FINDINGS AND RECOMMENDATION OFFICE OF PLANNING AND ZONING ANNE ARUNDEL COUNTY, MARYLAND

CASE NUMBER: 2025-0010-V **COUNCILMANIC DISTRICT**: 6th

REQUEST

The applicant is requesting a variance to allow a dwelling addition (first floor renovation, second floor addition, third floor half-story attic) with less setbacks than required and with disturbance to slopes of 15% or greater on property located at 3018 Friends Road in Annapolis.

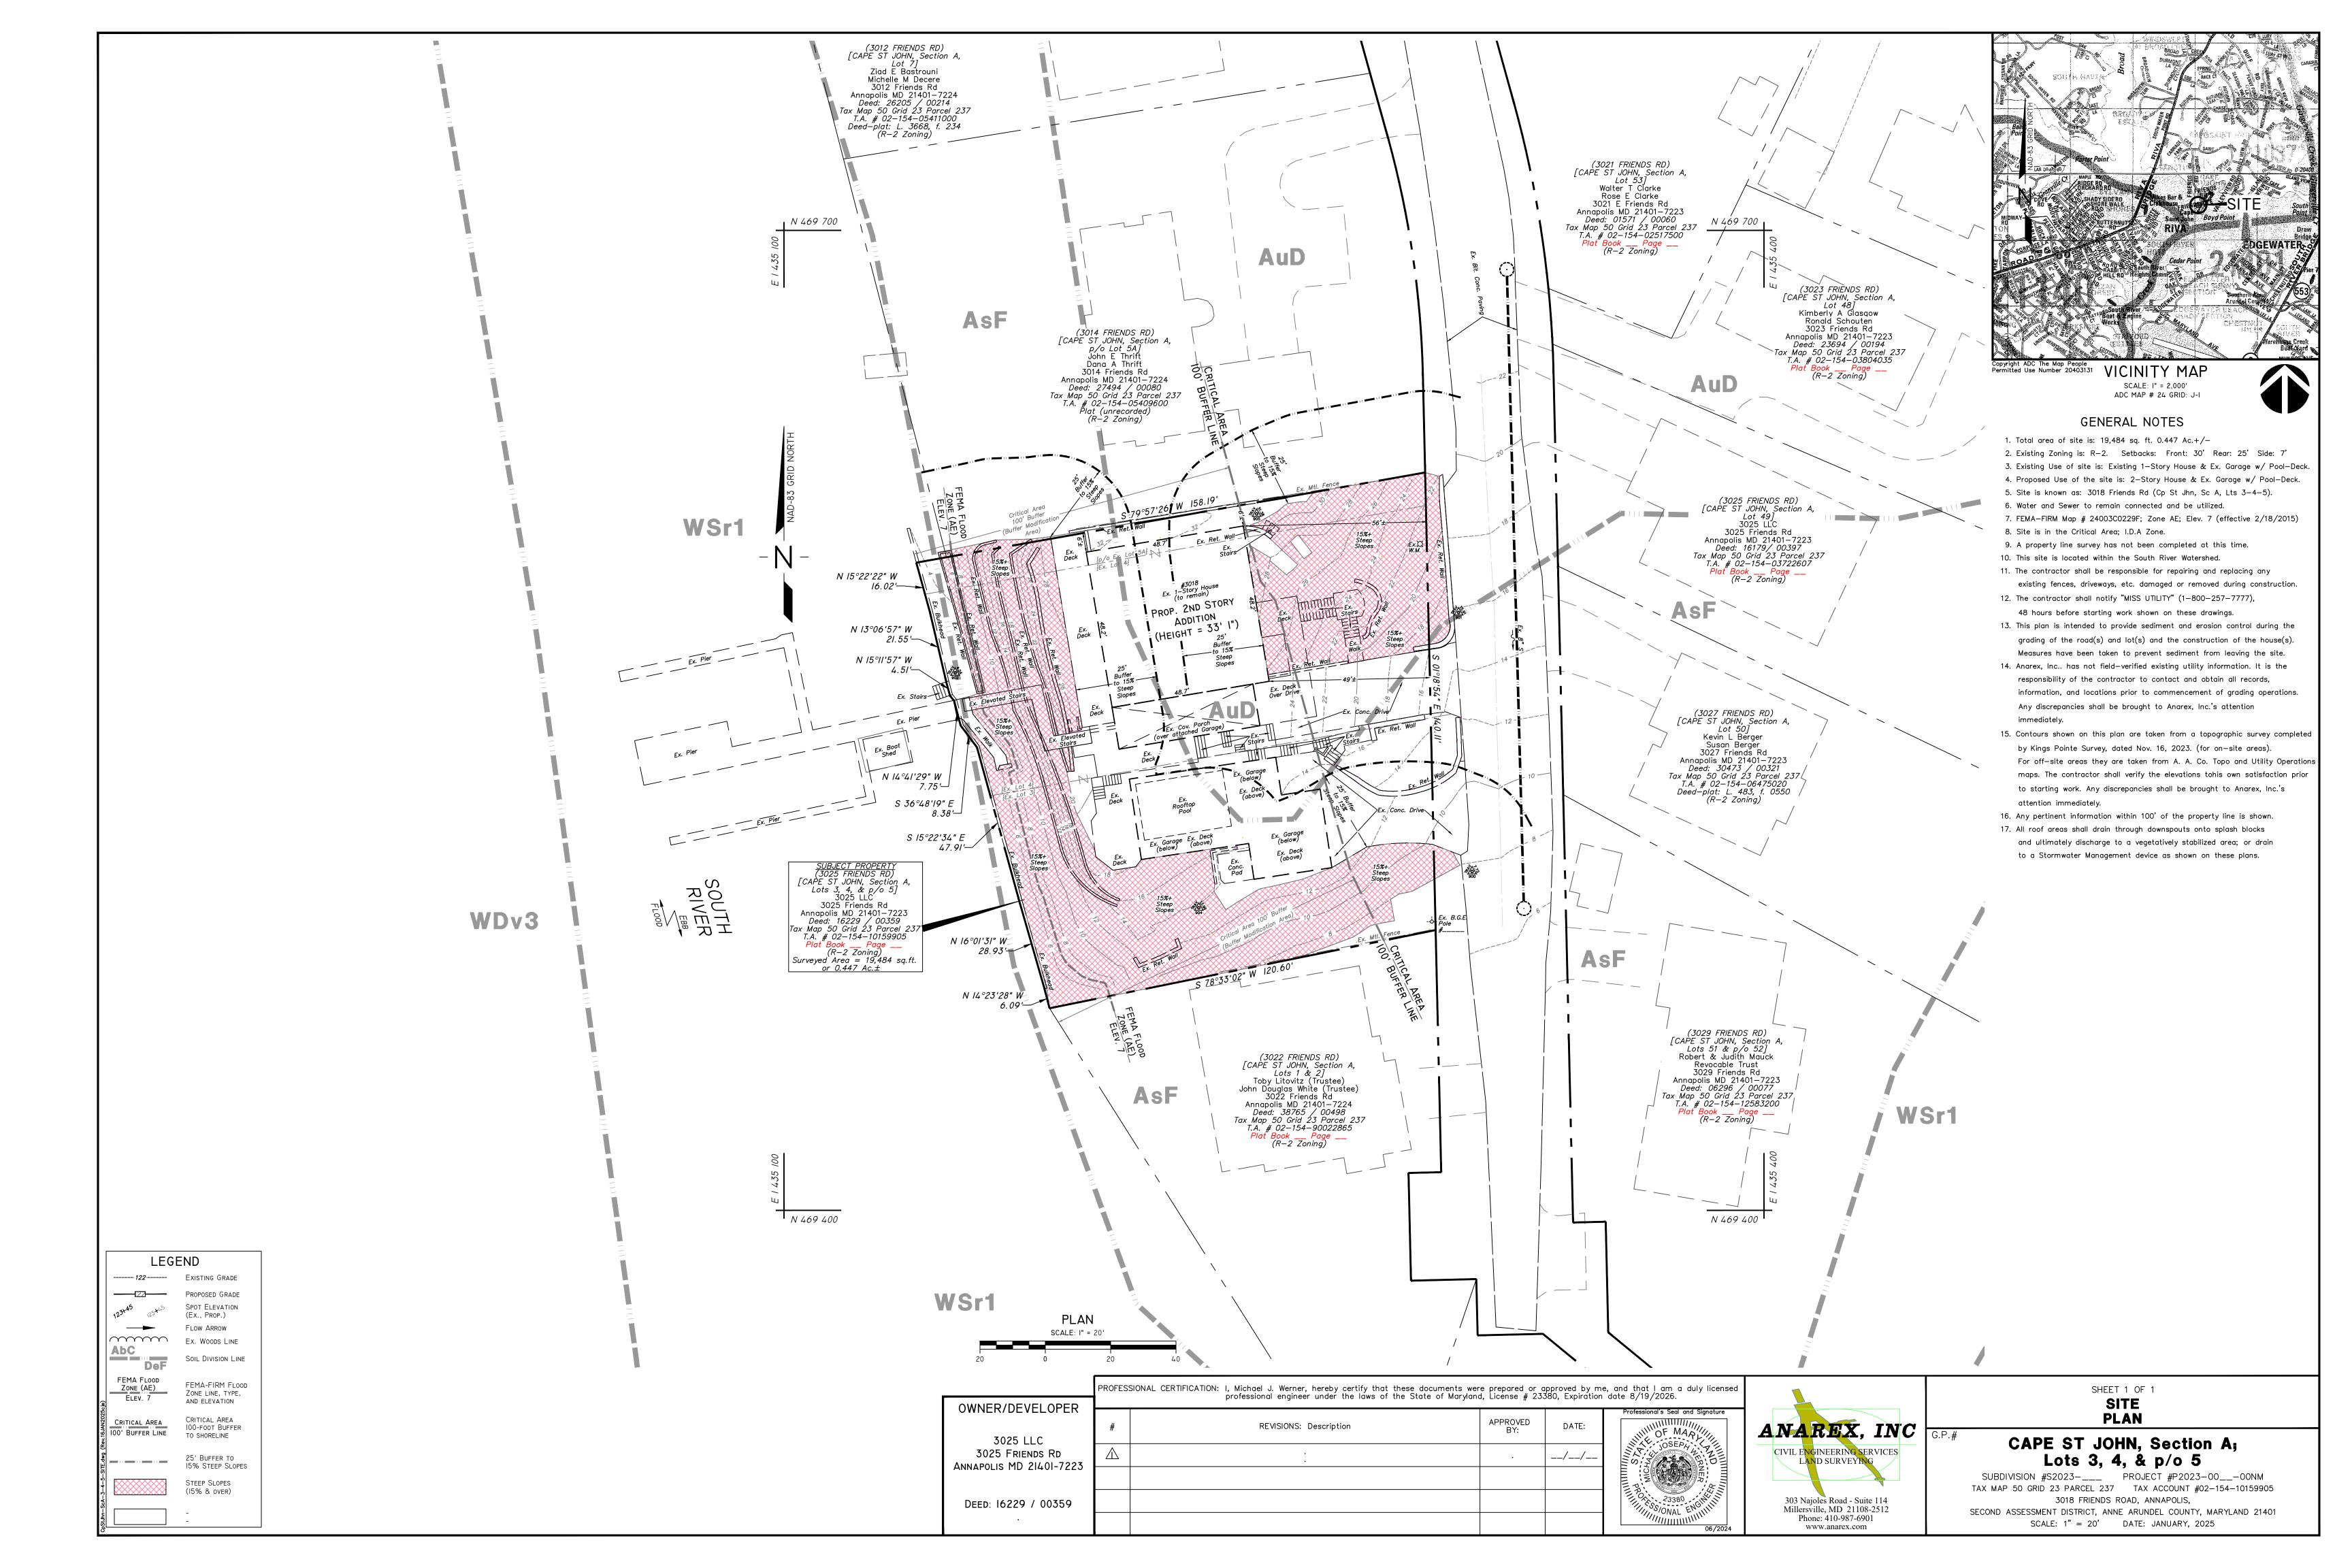
- 1. Label all stormwater management devices.
- 2. Comment #17 of the General Notes on the Site Plan states that "roof areas shall...drain to a Stormwater Management (SWM) device as shown on these plans." However, it does not appear that any SWM devices are shown on the Site Plan. However, the CA Report states that SWM is not required since disturbance is not above 5,000 sq ft. Clarify these comments by clearly stating whether or not SWM is proposed for this project.

- 3. Show and label the Limit of Disturbance on the Site Plan.
- 4. According to the Letter of Explanation, the disturbed area is listed as 2,210 sq ft, but in the CA notification report, it is listed as 3,471 sq ft. Ensure the disturbed area is consistent across all plans and reports.

- 5. On the Site Plan, show and label the location of the existing water line.
- 6. On the Site Plan, ensure the location of the existing water meter is accurate. The location shown on the Site Plan is about 10 feet south from where it is shown on Anne Arundel County's GIS map.

- 7. On the Site Plan, show and label the location of the existing sewer cleanout.
- 8. Comment #15 of the General Notes on the Site Plan states that off-site topography is taken from AA County Topo maps. However, the Site Plan does not show any offsite topography. Show the offsite topography and, in Comment #15, identify the year of the topography used. The latest topography available (2023) should be used.

- 9. The Site Plan legend shows a symbol for proposed contours. However, there are no proposed contours on the Site Plan. Show and label the proposed contours on the Site Plan.

- 10. The SDAT record lists the site's size as 20,654 sq ft. However, Comment #1 of the General Notes states the site's size as 19,484. Please ensure the site's size is accurate and consistent across all plans.

- 11. On the Site Plan, label all of the existing items (e.g. existing house, deck, etc) to show whether or not they are to remain or to be removed.
- 12. At the grading permit stage, label the size and type of pipe used on the public sewer line, the manhole number and reference the as-built from which this information was taken.
